UNITED STATES PATENT AND TRADEMARK OFFICE

Office Action Summary	Application No. 10/564,917	Applicant(s) JOHNSON ET AL.	
	Examiner GRANT D. SITTA	Art Unit 2629

DETAILED ACTION

FIG. 8

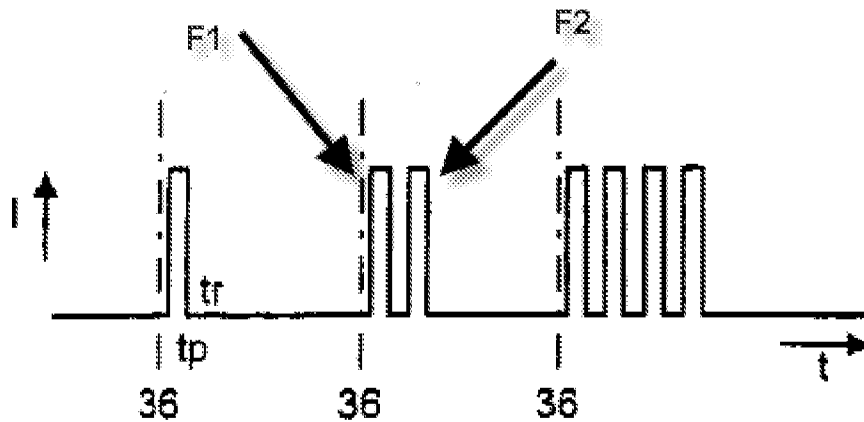
21. With respect to Applicant's arguments that Friend fails to disclose elements of a "non-zero" current during the second period. Examiner respectfully disagrees. Friends states, "[a]ccording to a first aspect of the invention there is provided an organic light-emitting having: an organic light-emitting region comprising a plurality of organic light-emitting pixels; first switch means each associated with a respective pixel for switching power to that pixel; and drive means for driving each switch means between a first, low power mode and a second, high power mode, at a frequency sufficient to cause light emission from the associated pixel to appear substantially continuous, the duration of the high power mode relative to the low power mode being variable so as to vary the average brightness of the pixel over the duration of a cycle" (col. 2, lines 53-67).

Examiner is interpreting (36), a cycle, to be a frame. Examiner is interpreting each pulse as a sub-period. Therefore, for instance in fig. 8 below the first pulse would be a first sub-period, which contains a "non-zero" value. Next, a low power mode during the subsequent sub-period. After the low power mode, a second pulse is applied which is a "non-zero" pulse.

Applicant also contends the "off" periods are defined. Examiner notes that the current claim limitations do not require the absence of "zero" periods, only a first and second sub-period containing a "non-zero" current substantially yielding said overall brightness level. Although the claims are interpreted in light of the specification, limitations from the specification are not read into the claims. See *In re Van Geuns*, 988 F.2d 1181, 26 USPQ2d 1057 (Fed. Cir. 1993).

For the reasons stated above the rejection is maintained.
